Planning Commission Meeting

Wednesday, July 24, 2024

Final Plan Review for New Home

Hearing Date:	July 24, 2024
File Name and Process:	Single-Family Residence Final Plan Review
Owner/Applicant:	Mikel Goicoechea & Stephanie Gullledge
Representative:	Taylor Hermes & Rick Hermes, Minturn North Construction Company
Legal Description:	Subdivision: MINTURN NORTH PUD Lot: 3
Address:	0226 Miles End Lane
Zoning:	Game Creek Character Area – Minturn North PUD Zone District
Staff Member:	Madison Harris, Planner I
Recommendation:	Approval

Sheet
C.7

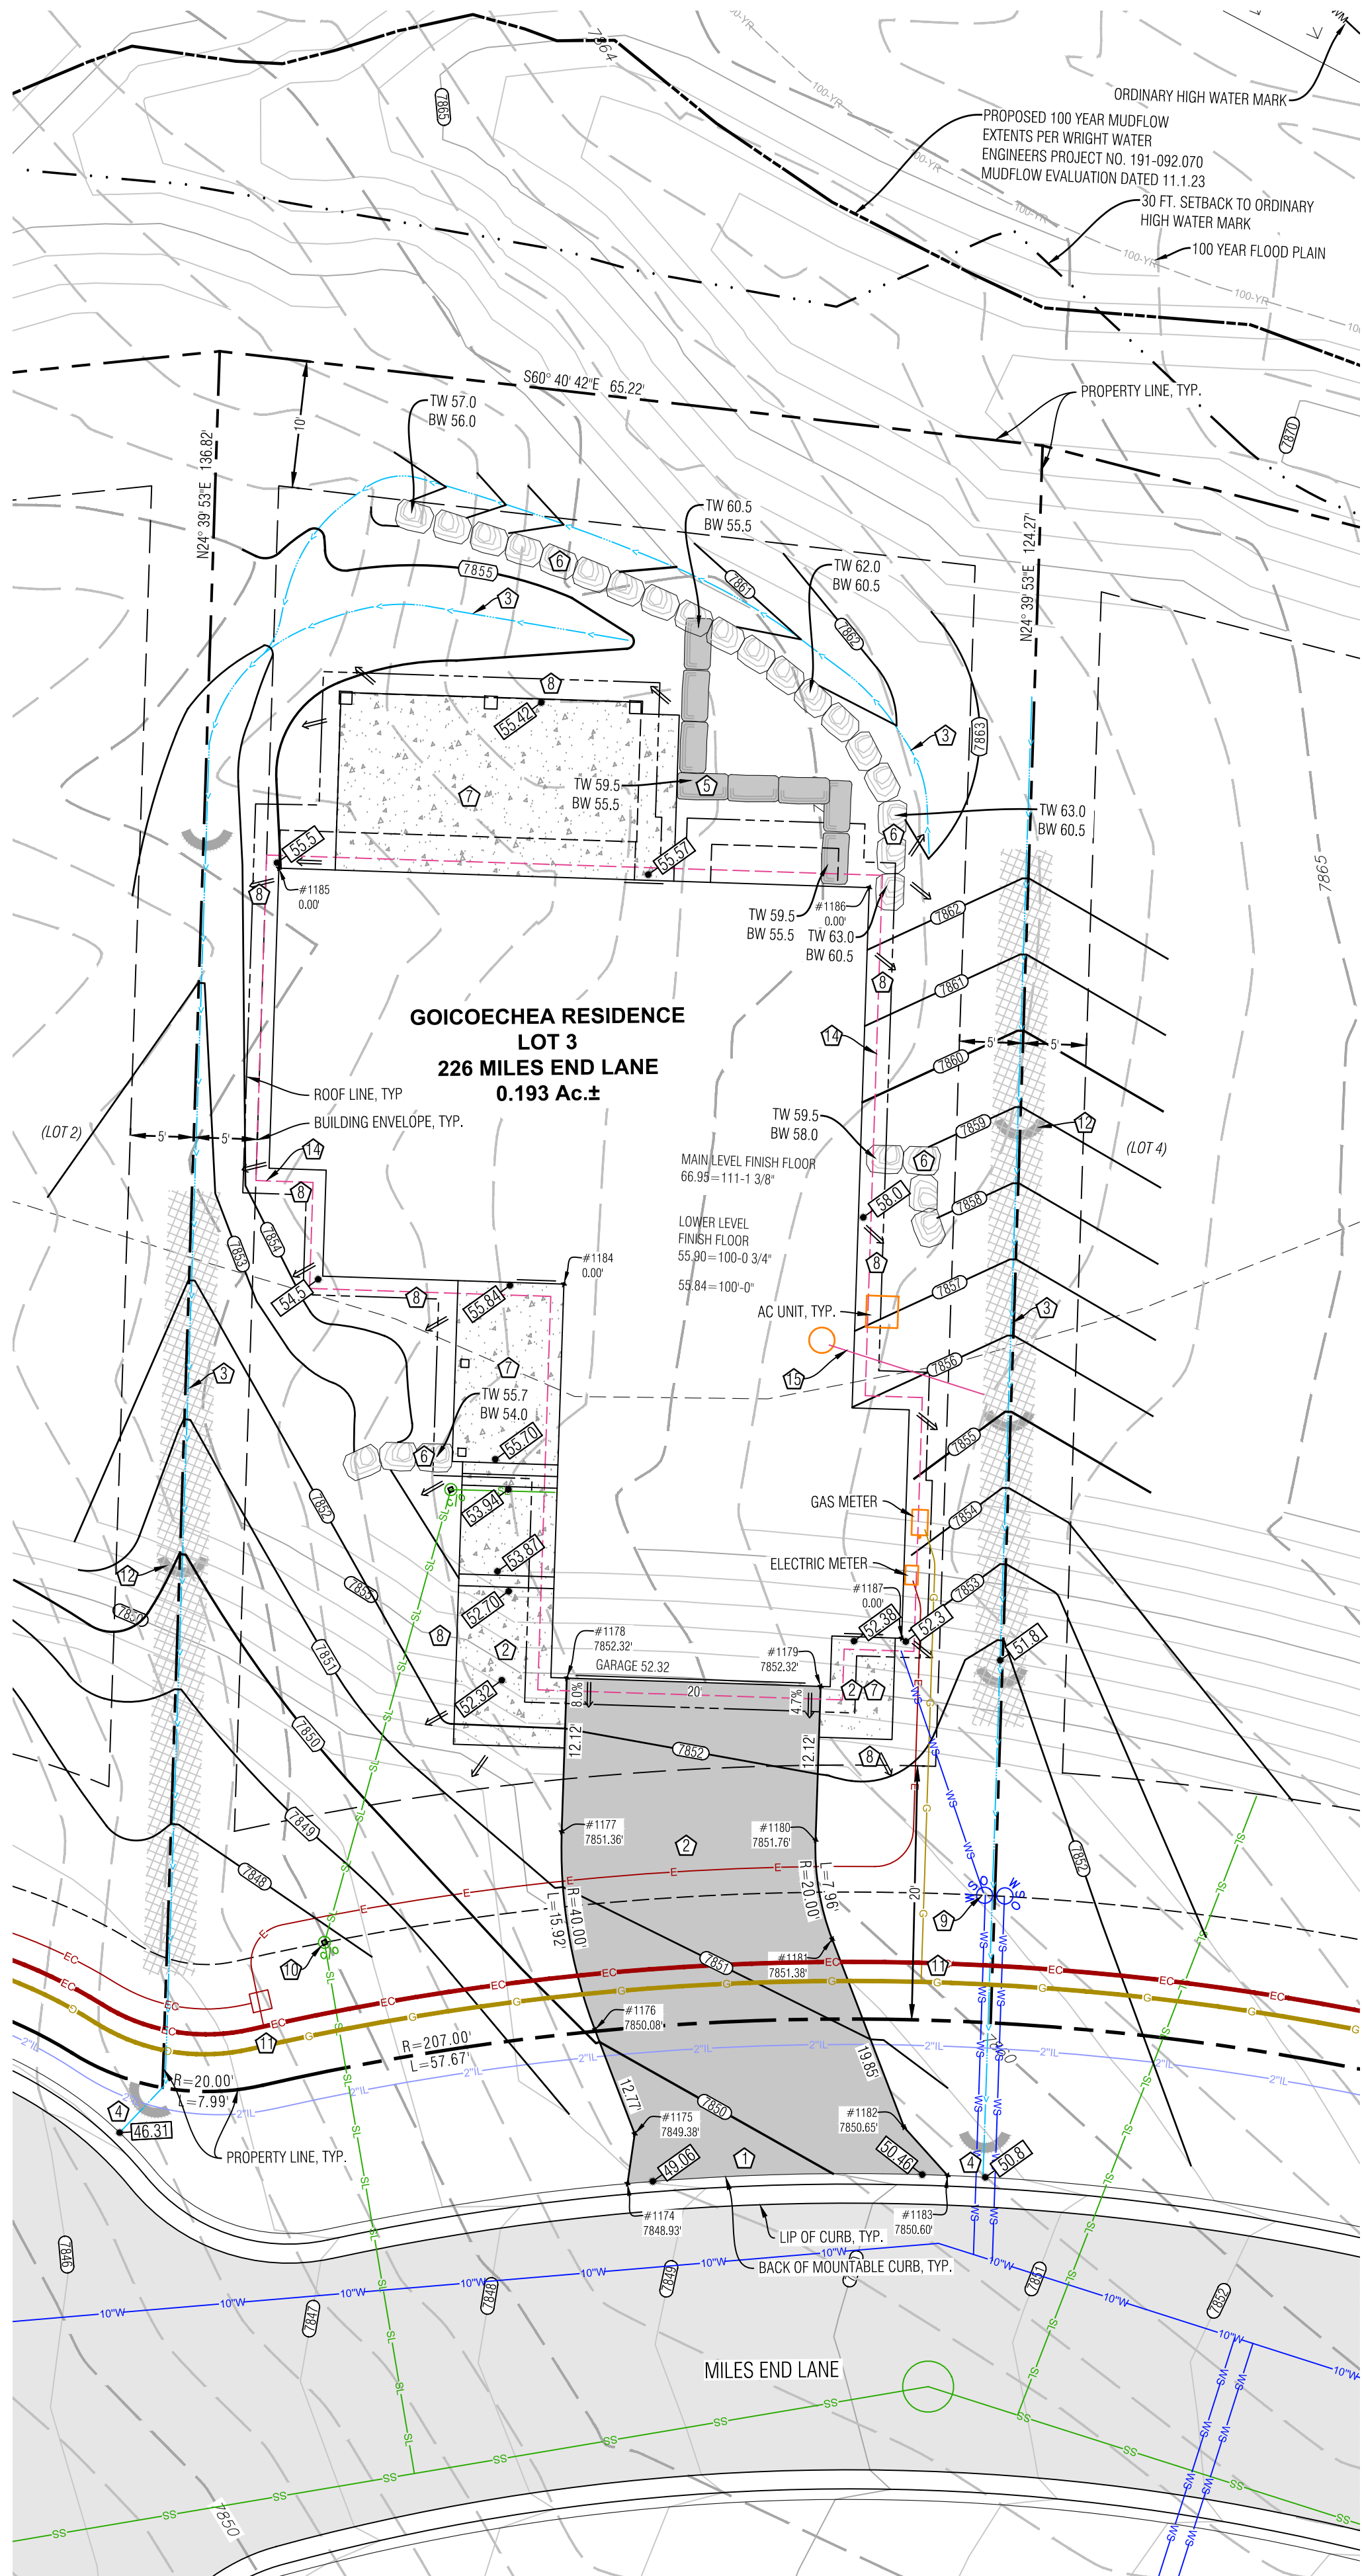
3. The site plan shows a “High Water Mark.” The “Ordinary High Water Mark (OHWM)” as defined in section 17-2-10 of the MMC along with required setbacks should be shown on the site plan. The OHWM is shown on Sheet C.7 of “Minturn North PUD Overall Grading and Drainage Plan; Construction Plan Set 5/1/24” and the “Final Plat: Minturn North PUD” recorded March 4, 2024, referenced above. The OHWM should be labeled on the permit set of plans.

1. The Applicant shall label the Ordinary High Water Mark (OHWM) on the site plan prior to or concurrent with building permit application.

Sheet
C1

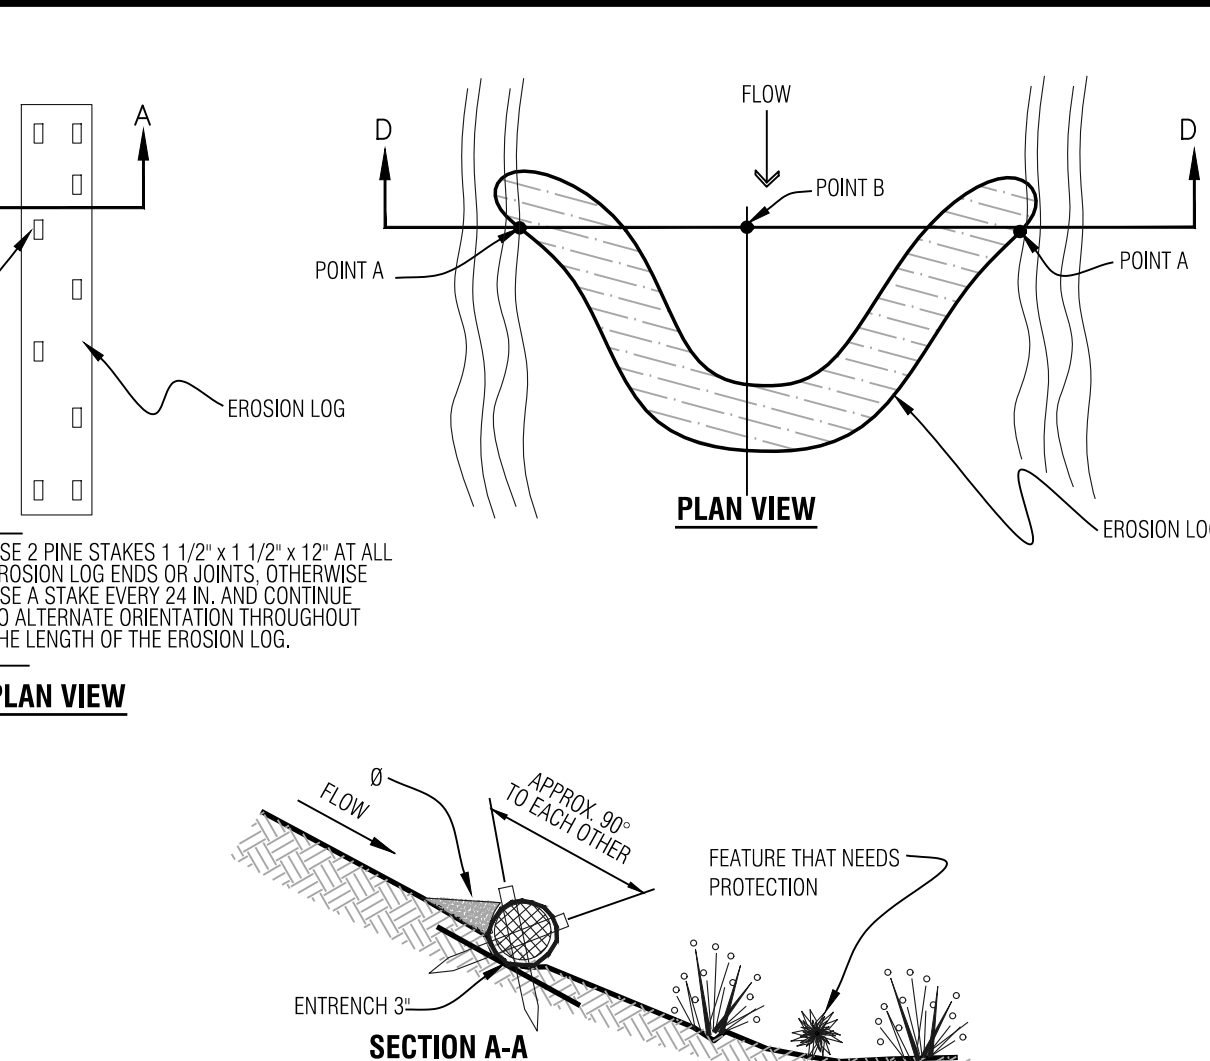
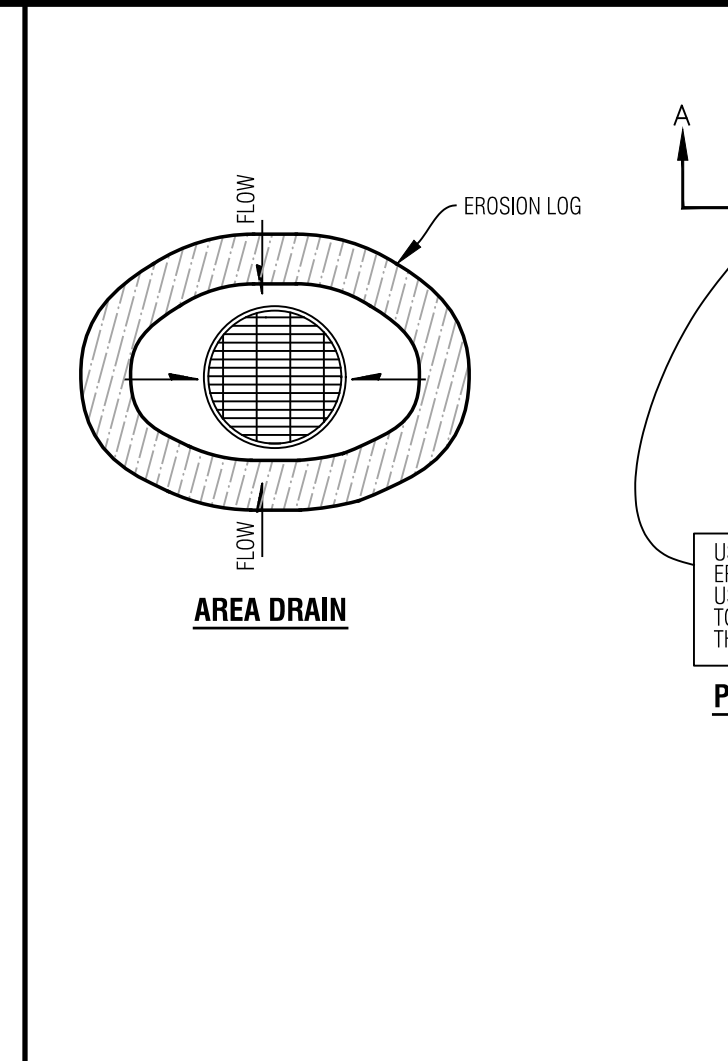
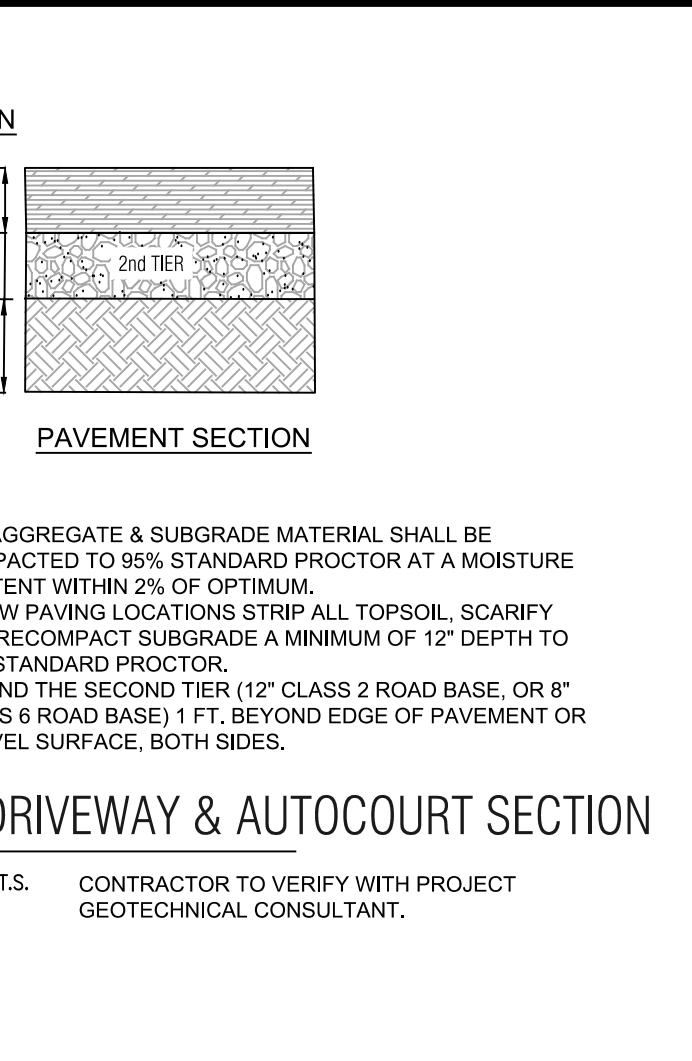
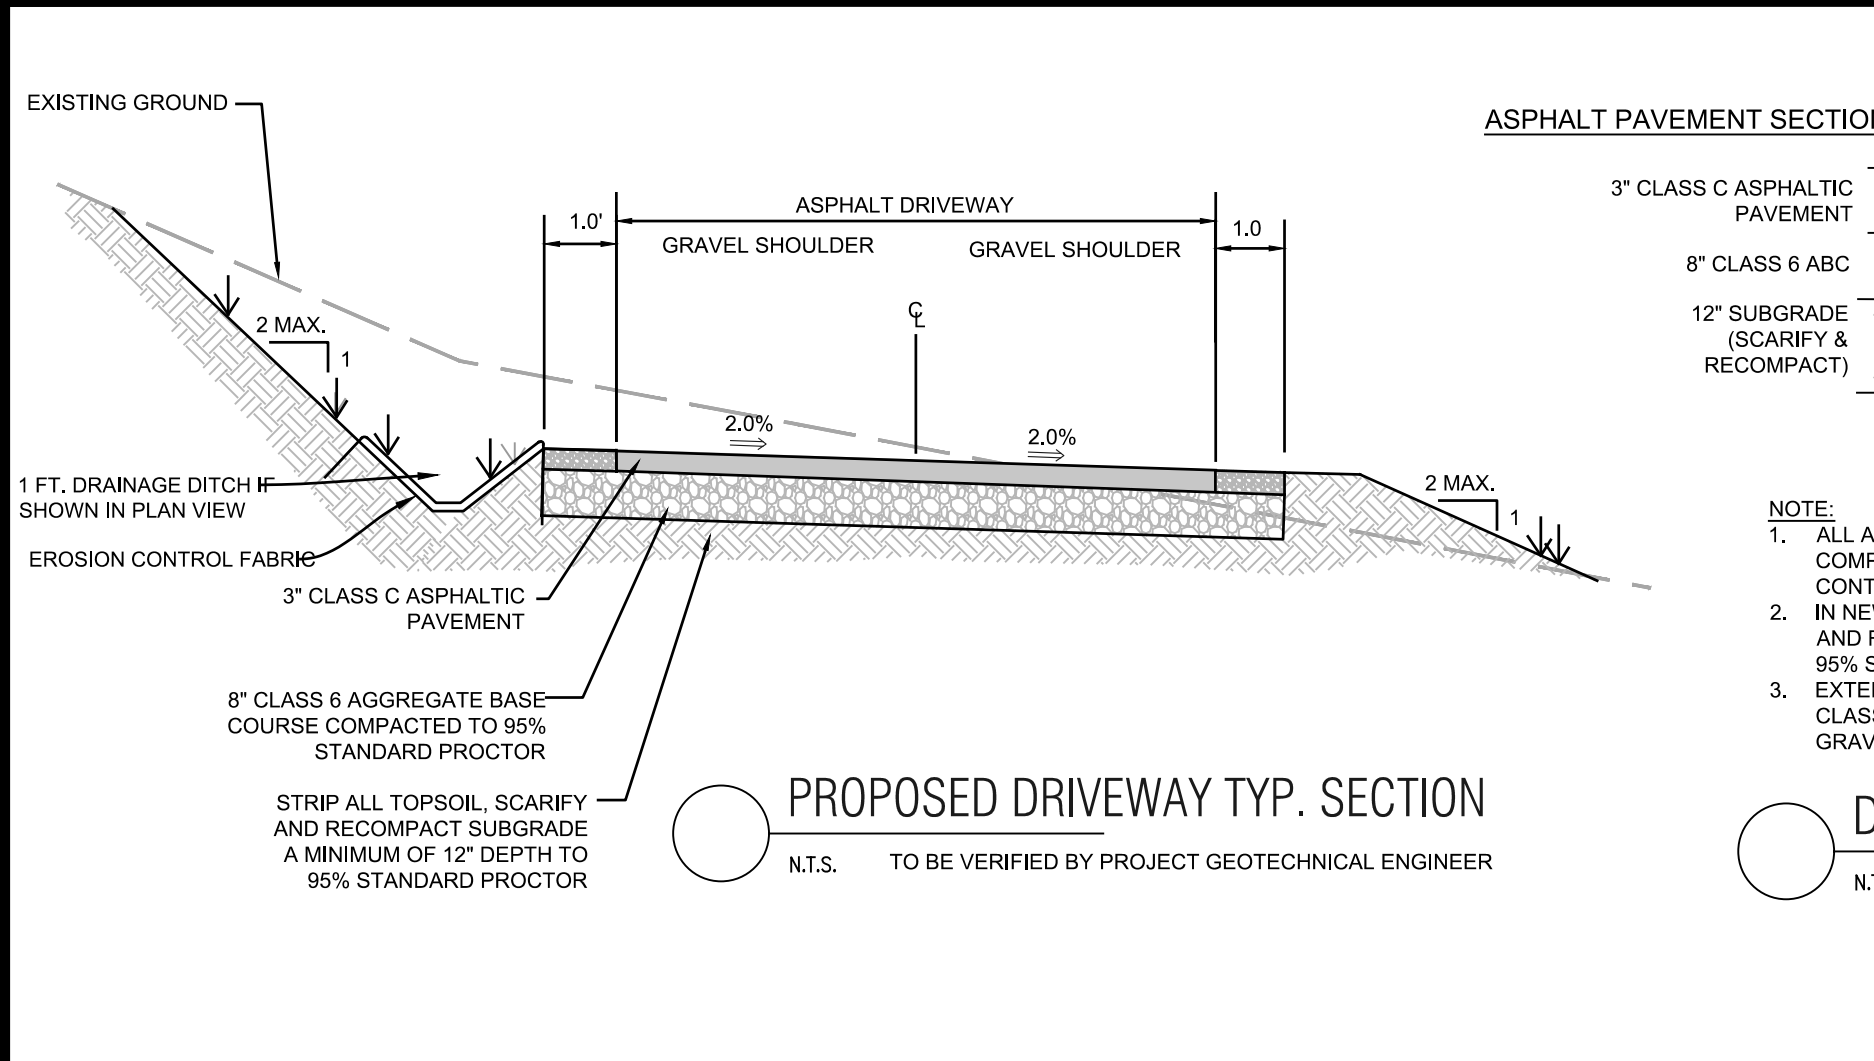
Sheet C1 of the Plans “Lot 3 Minturn North PUD; Site Grading and Drainage Plan” dated June 1, 2024, by Boundaries Unlimited presents the proposed site grading and drainage and fulfills Grading and Drainage Plan requirements.
